Petition No. 2020-044

Petitioner: Charlotte Planning, Design and Development

**AN ORDINANCE AMENDING APPENDIX A OF
THE CITY CODE –ZONING ORDINANCE**

Transit Trail and Planting Strip Dimensions

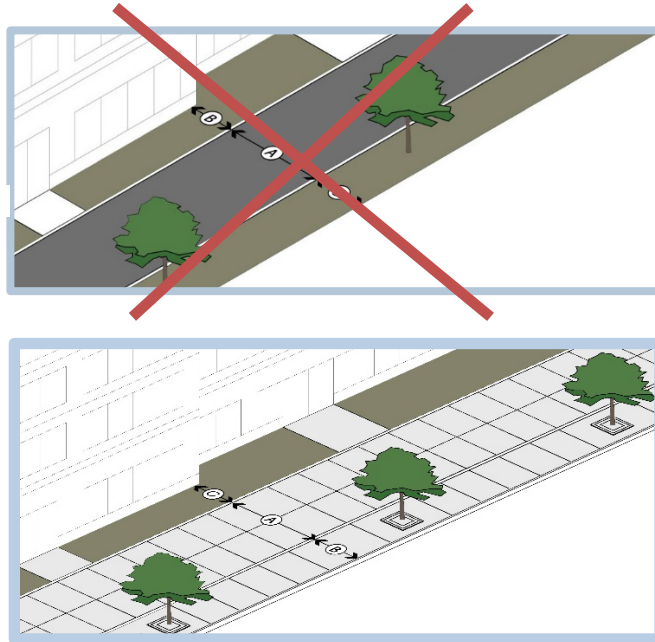
27. Amend Section 15.4.4, “Pedestrian Facilities and Planting Strip/Amenity Zone Standards”, subsection B, “Transit Trail” by deleting the term “perimeter” from the Transit Trail and Planting Strip Dimensions Table, located in the second column of subsection B. In addition, delete the term, “only” from the first footnote. The revised Table and footnotes shall read as follows:

* A transit trail is ~~only~~ required when the trail is identified in a Council-adopted plan.

** No trees will be required in the planting strip.

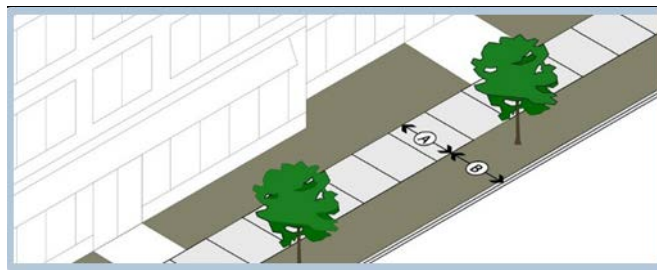
31. Amend Section 15.4.4, “Pedestrian Facilities and Planting Strip/Amenity Zone Standards”, Table, “Sidewalk and Amenity Zone Dimensions” by deleting the term,

“perimeter” from the double asterisk (**) footnote. The other footnote remains unchanged. The revised double asterisk shall read as follows:

** In TOD-TR, a ~~perimeter~~ planting strip is permitted in lieu of an amenity zone.

I. Cross Charlotte Trail (XCLT)*

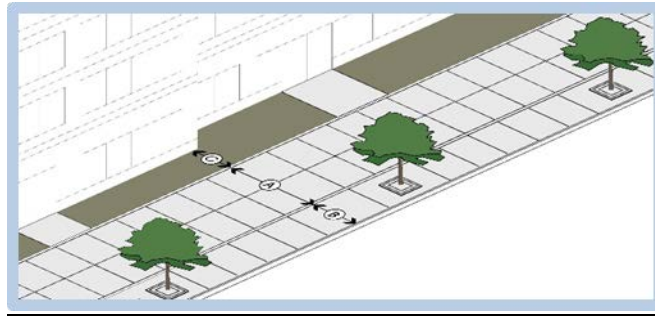
33. Amend Section 15.4.4, “Pedestrian Facilities and Planting Strip/Amenity Zone Standards”, by adding a new subsection I, titled “Cross Charlotte Trail (XCLT)**” that includes a new graphic, text, table and asterisks. The new Section 15.4.4.I shall read as follows:

* The Cross Charlotte Trail is required when the trail is identified in a Council-adopted Streets Map or adopted Area Plan. When the Streets Map or Area Plan indicates that the Cross Charlotte Trail (XCLT) is to be provided on a Limited Access frontage, the location of the trail will be determined by CDOT, and NCDOT if applicable.

*** To determine the requirement for amenity zone or planting strip, see Section 15.4.4 subsections E, F, G, and H.

**** Either an amenity zone or planting strip is allowed.

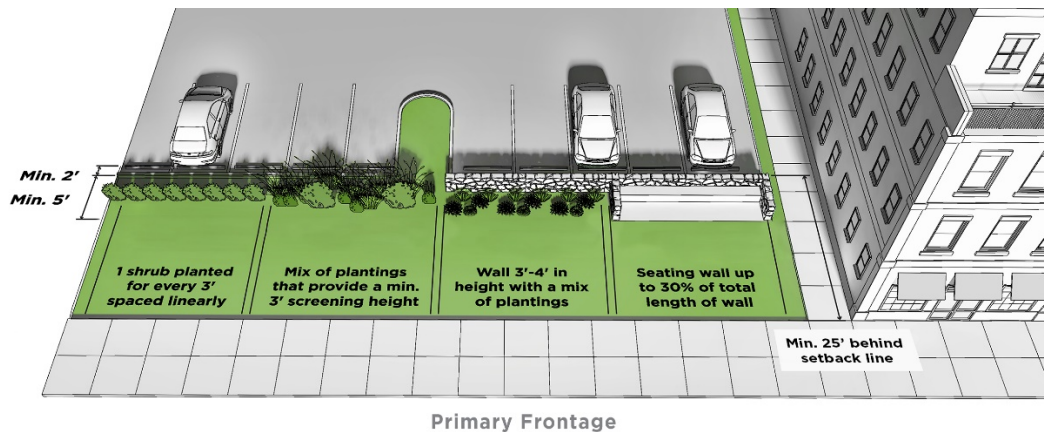
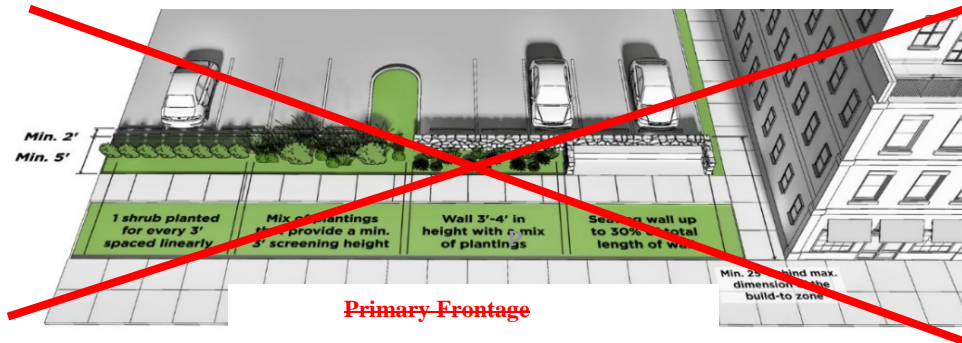
40. Amend Section 15.5.5, “Parking Location and Access”, subsection F by clarifying the requirements. The revised Section 15.5.5.F shall read as follows:

1. Access to surface parking lots shall be located ~~at~~ to the side or to the rear of a structure.

2. Access shall be from the secondary frontage when available.
 3. No access shall be allowed from ~~street~~ frontages located across from single-family residential zoning districts. If all frontages are located across from single-family residential districts, the Planning Director will determine how access can be achieved with minimal intrusion into a single-family neighborhood.

Blank Wall, Upper Floor

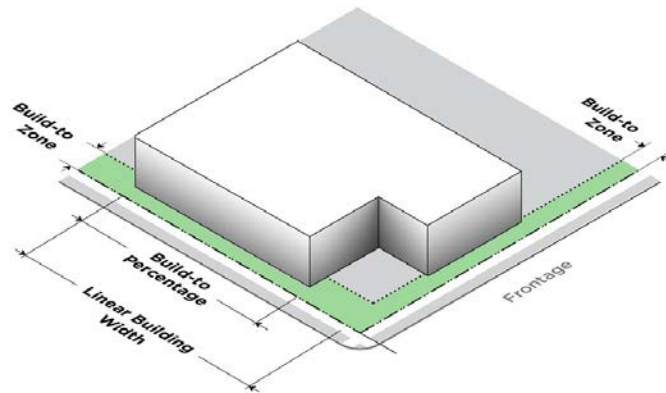
63. Amend Section 15.13.2 “Definitions” by the following:
- Modify the definition for “Blank Wall Upper Floor”, and delete the associated graphic.
 - Delete the existing graphic for “Build-to Percentage”, and replace it with a new graphic.
 - Delete the definitions and graphics for “Multi-Family Attached Unit” and “Multi-Family Stacked Unit”. [These definitions and graphics are being relocated into Section 5.8.5.]
 - Modify the definition for “Utilities (On-Site)” by changing the title to “Utilities, Above Ground Accessory Structures”, and revising the first sentence.

Blank Wall, Upper Floor. The horizontal or vertical linear dimension of contiguous building wall that does not contain fenestration, doors, or decorative elements such as banding, medallions, artwork such as murals and mosaics, change in wall plane of at least three inches, or other architectural or material embellishment. ~~Any wall with a minimum dimension of less than five feet (height or width) is not considered to be a blank wall. A wall does not count as a blank wall as long as one of the dimensions of the wall area is less than the maximum dimension in Section 15.2.E.B.~~
